# Access Compliance Report

## Public Rights-of-Way (Curb Ramps)

Intersection ID: 51072	Main Street: KEMPSFORD_DR	Cross Street: GRICKLADE_DR	Location: NW
ADA ID: 42AE6CD132FF	Ramp Type: Perp	Initial Pass/Fail: Fail	Overall Compliance: No
		Severity Score: 12.5

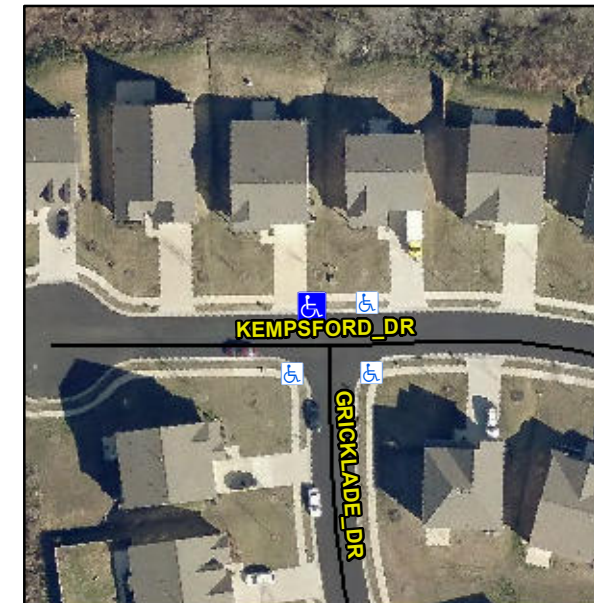
**Not Found, R304.2.2**

Compliance	Description	Data	Compliance	Description	Data
N/A	Ramp Length (in)	48.0	No	Ramp Slope (%)	11.6
Yes	Ramp Width (in)	48.0	Yes	Ramp XSlope (%)	1.6
N/A	Flare Type LT	N/A	N/A	Flare Type RT	N/A
N/A	Flare Slope LT (%)	N/A	N/A	Flare Slope RT (%)	N/A
N/A	Flare Traversable LT?	N/A	N/A	Flare Traversable RT?	N/A
N/A	Landing Length (in)	N/A	N/A	DWS Provided?	N/A
N/A	Landing Width (in)	N/A	N/A	DWS Contrast?	N/A
N/A	Landing Slope (%)	N/A	N/A	DWS Length (in)	N/A
N/A	Landing X Slope (%)	N/A	N/A	DWS Full Width?	N/A
N/A	Landing Curb? (Y/N)	N/A	N/A	DWS Offset (in)	N/A
N/A	Shared Landing?	N/A			
N/A	Gutter Ponding?	N/A	N/A	Gutter Slope (%)	N/A
N/A	Gutter Lip Ht (in)	N/A	N/A	Gutter X Slope (%)	N/A
N/A	Painted X Walk1?	No	N/A	Painted X Walk2?	N/A
	X Walk 1 Direction	To S		X Walk 2 Direction	N/A
N/A	X Walk 1 Width (in)	N/A	N/A	X Walk 2 Width (in)	N/A
	X Walk 1 Slope (%)	3.2		X Walk 2 Slope (%)	N/A
	X Walk 1 X Slope (%)	2.0		X Walk 2 X Slope (%)	N/A

**Remove & Replace Entire Ramp.**
